Service Bulletin

SUBJECT: Service Update for Inventory and Customer Vehicles
Insufficient Evaporative Emission Canister Capacity for Vapor Generation

MODELS: 2014-2015 Cadillac ELR
2011-2015 Chevrolet Volt
Expires With Applicable New Vehicle Limited Warranty Coverage Periods,
Including Voltec Component Limited Warranty

3997266

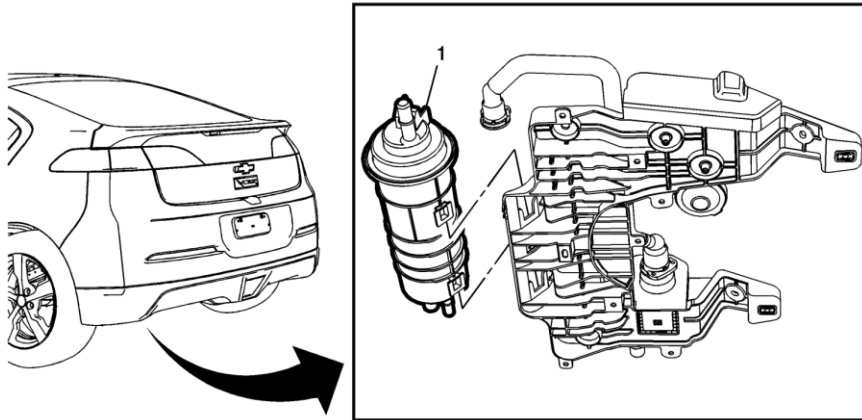
1. Remove the evaporative emission hose (1). Refer to *Evaporative Emission Hose Replacement* in SI.
2. Install a new evaporative emission hose (1). Refer to *Evaporative Emission Hose Replacement* in SI.
